Nutrient Concentrations in Big Creek Correlate to Regional Watershed Land Use (BCRET) - A Technical Response

David Peterson, PhD, Michigan State (1971), Mathematics
56 Ridge Drive, AR 72058, 501-679-2935, drpdrp@windstream.net, 12/30/17

Figure 2

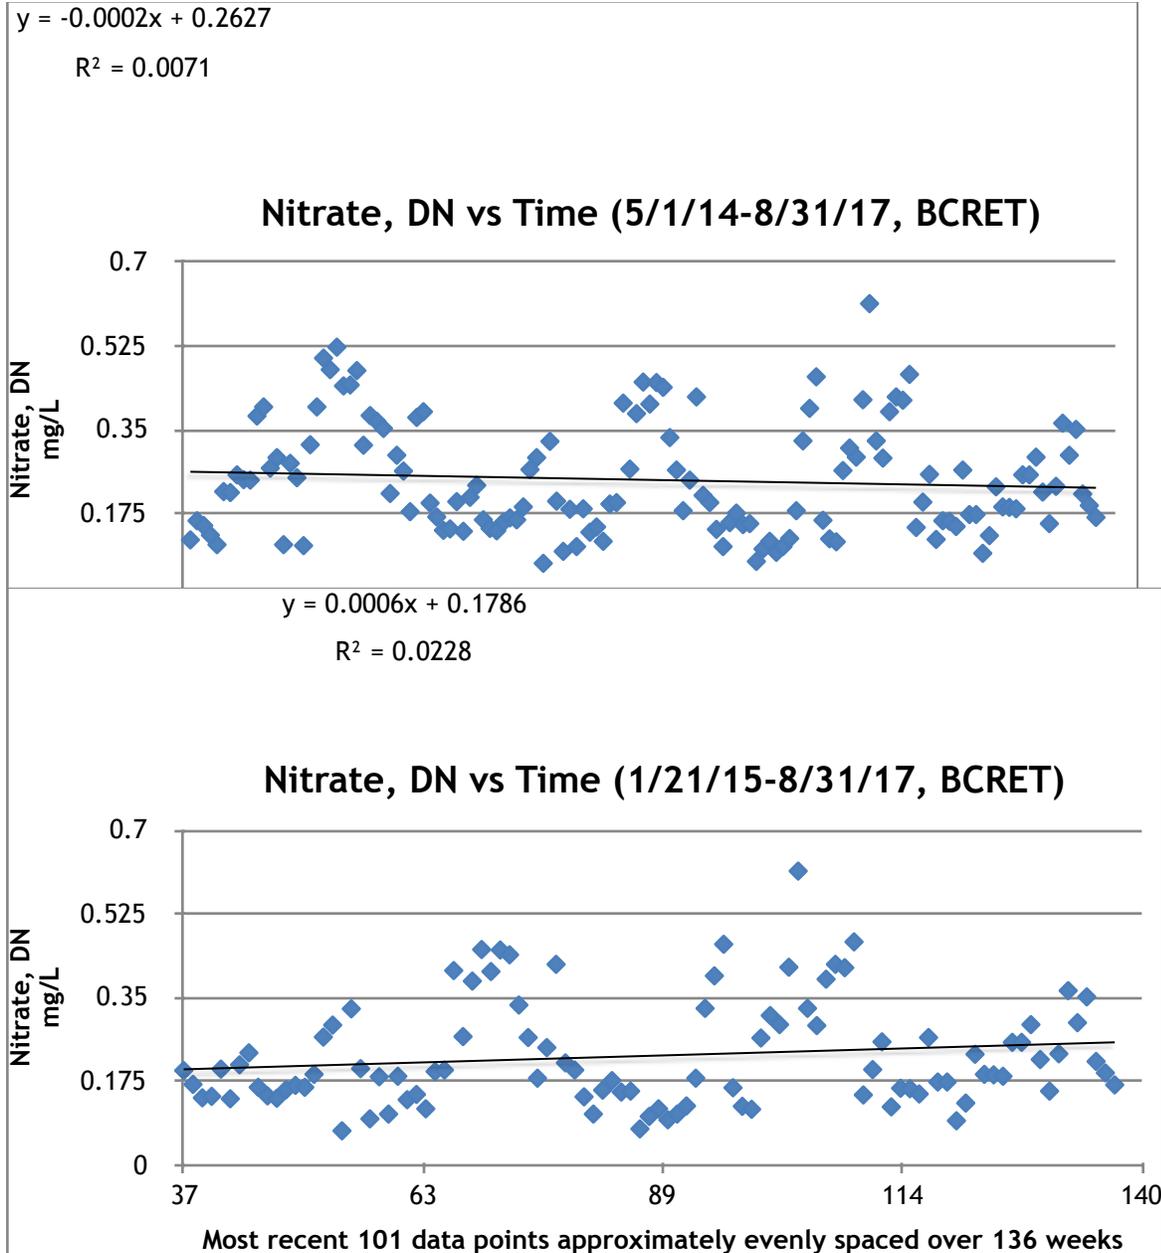
The slope is positive and 3 times larger than before, giving an estimated 34% increase over $2\frac{3}{4}$ years. Of course this is cherry picking the data (both times), but it also confirms that more time is needed for reliable decisions. There are lots of data points, $n = 137$, but only $n = 3$ years of weather cycles.

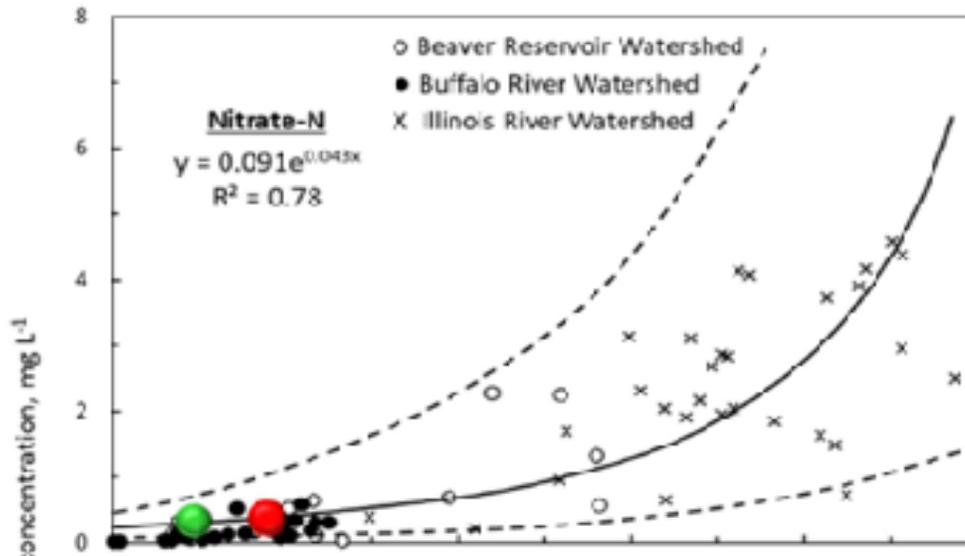
The green and red dots are big, but the model is a clear miss at the upstream site: model = 0.143 mg/L, actual = 0.093. The model predicts a 53% increase as pasture/urban goes from 10.6 to 20.5 percent, but the actual increase is 137%.

For TN the model predicts a 39% increase, but the actual increase is 81%

For TP, the model predicts 0.016 mg/L at the upstream site vs the actual 0.0284. The predicted increase is 22% but the actual increase is 12%. For dP the predicted increase is 24% but the actual increase is 33%.

The ratio of dP to TP at Mt Judea is 0.29 (UP) and 0.34 (DN). The model predicts, $dP/TP = 0.615\exp(0.002x)$, greater than 0.615 for all x - and therefore not remotely close at Mt. Judea and implausible for the other tributaries, e.g. 0.40, 0.065, 0.31 for Mill Creek, Tomahawk Creek, and Leatherwoods Creek.

How about the predicted ratio of nitrate to TN, $\text{nitrate}/\text{TN} = 0.42\exp(.01x)$, which is greater than 1 for $x > 85\%$, whereas by definition, nitrate < TN!
